Product/Process Change Notice (PCN)	
<input type="checkbox"/> Major Change <input checked="" type="checkbox"/> Minor Change	
PCN Number: PCN_PeBUFU_20250204 Affected Series: WP-BUFU Affected Part Number: 7461099 PCN Date: 2024-11-04 (YYYY-MM-DD) Effective Date: 2025-02-04 (YYYY-MM-DD)	Change Category: <input type="checkbox"/> Equipment/Location <input checked="" type="checkbox"/> General Data <input type="checkbox"/> Material <input type="checkbox"/> Process <input type="checkbox"/> Product Design <input checked="" type="checkbox"/> Shipping/Packaging <input type="checkbox"/> Supplier <input type="checkbox"/> Software
Contact: Product Management Phone: +49 (0) 7942 - 945 5001 Fax: +49 (0) 7942 - 945 5179 E-Mail: pcn.eican@we-online.com	Datasheet Change: <input checked="" type="checkbox"/> Yes <input type="checkbox"/> No Attachment: <input type="checkbox"/> Yes <input checked="" type="checkbox"/> No

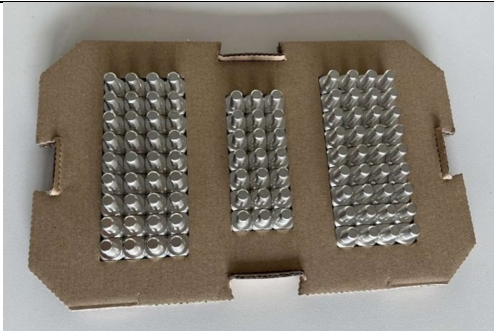
DESCRIPTION OF CHANGE: <p>Due to an improvement of the production capability, Würth Elektronik eiSos will change the packaging from carton to carton tray. The new carton will change the SPQ an CPQ.</p> <p>In addition, because of database mismatch the value of the total height is placed in brackets.</p> <p>There will be no change in form, fit, function, quality or reliability of the product.</p> <p>The new revision of the affected order codes will be sent out after the previous revision is out of stock (according to FIFO - first-in, first-out).</p>	
DETAILS OF CHANGE: <p>The new packaging will look like showed in the pictures below.</p>	
Before Change	After Change

Dimensions (LxWxH):	Dimensions (LxWxH):
139.0 x 89.0 x 97.0 mm	274.0 x 171.0 x 15.0 mm

Before Change		After Change

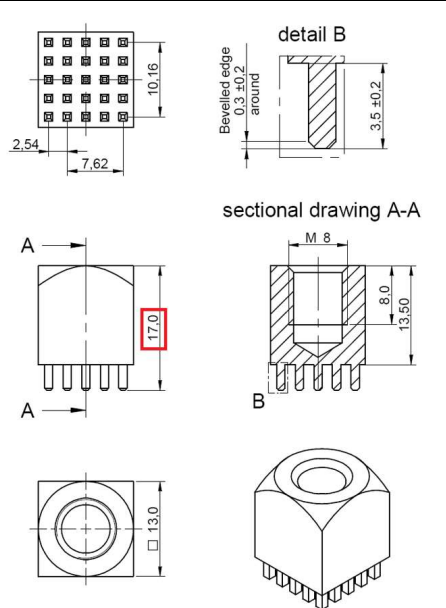
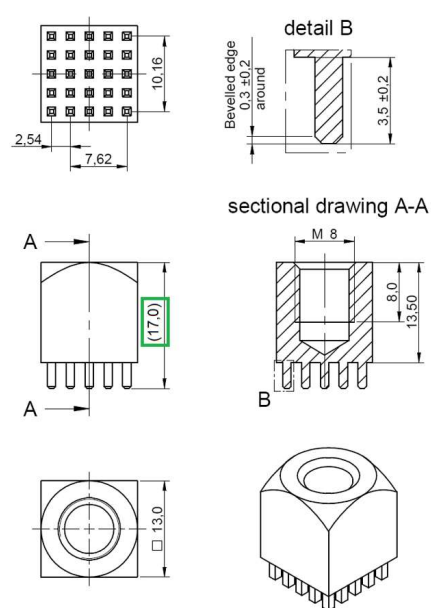
Dimensions (LxWxH):		Dimensions (LxWxH):		
300.0 x 200.0 x 115.0 mm		300.0 x 200.0 x min. 115.0 mm Height varies depending on the component due to two-part carton.		
Before Change		After Change		
General Information:		General Information:		
Material	Brass	Material	Brass	
Surface	Tin	Surface	Tin	
Execution	Press-Fit	Execution	Press-Fit	
Operating Temperature	-55 up to +150 °C	Operating Temperature	-55 up to +150 °C	
Packaging	Bulk	Packaging	Tray	
Order Code	Before Change		After Change	
	SPQ: Carton case	CPQ: Carton	SPQ: Carton Tray	CPQ: Carton
7461059	144	-	93	465
